Important Safety Notice

HDE/ Greenlee RT-10 Rope Tester & CT-300 ClearTest® Transformer Tester That Use Two Batteries

March 9, 2022

Figure 6 - Unit carton Label includes marking "Uses one 9V Lithium battery (included)." Not subject to safety notice

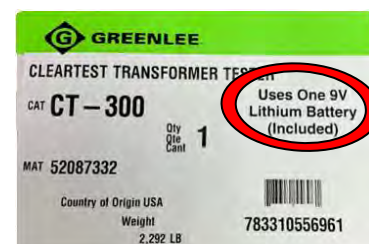
If the Tester has been reworked by Greenlee / HDE to remove contacts in one of the 9V battery compartments (as shown in figure 4) or has a single battery compartment (as shown in figure 5) the tester unit is not affected and is not subject to this Safety Notice. If the unit is in its original carton, and the carton label has the words "Uses one 9V Lithium battery (included)" on the label (see figure 6), the tester unit inside the carton is not affected and is not subject to this Safety Notice.
